Access Compliance Report

Public Rights-of-Way

(Curb Ramps)

Intersection ID: 10036981	Main Street: S_TRYON_ST	Cross Street: N/A	Location: SE
ADA ID: 3991CFE662B6	Ramp Type: PerpDiag	Initial Pass/Fail: Fail	Overall Compliance: No
Severity Score: 33.75			
Codes/Mitigation Info/Possible Solution		Field Measurements/Component Compliance

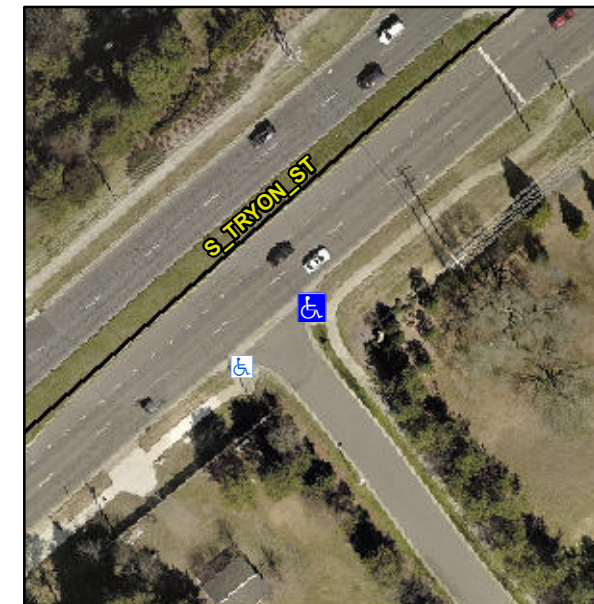
R304.5.1, R304.2.2, R304.5.3

Compliance	Description	Data	Compliance	Description	Data
N/A	Ramp Length (in)	85.0	No	Ramp Slope (%)	8.4
No	Ramp Width (in)	47.0	No	Ramp XSlope (%)	5.1
N/A	Flare Type LT	N/A	N/A	Flare Type RT	N/A
N/A	Flare Slope LT (%)	N/A	N/A	Flare Slope RT (%)	N/A
N/A	Flare Traversable LT?	N/A	N/A	Flare Traversable RT?	N/A
N/A	Landing Length (in)	N/A	N/A	DWS Provided?	N/A
N/A	Landing Width (in)	N/A	N/A	DWS Contrast?	N/A
N/A	Landing Slope (%)	N/A	N/A	DWS Length (in)	N/A
N/A	Landing X Slope (%)	N/A	N/A	DWS Full Width?	N/A
N/A	Landing Curb? (Y/N)	N/A	N/A	DWS Offset (in)	N/A
N/A	Shared Landing?	N/A			
N/A	Gutter Ponding?	N/A	N/A	Gutter Slope (%)	N/A
N/A	Gutter Lip Ht (in)	N/A	N/A	Gutter X Slope (%)	N/A
N/A	Painted X Walk1?	No	N/A	Painted X Walk2?	No
	X Walk 1 Direction	To NW		X Walk 2 Direction	To SW
N/A	X Walk 1 Width (in)	N/A	N/A	X Walk 2 Width (in)	N/A
	X Walk 1 Slope (%)	0.6		X Walk 2 Slope (%)	3.9
	X Walk 1 X Slope (%)	3.1		X Walk 2 X Slope (%)	0.8

Remove & Replace Curb Ramp With Two New Directional Ramps or Equivalent.
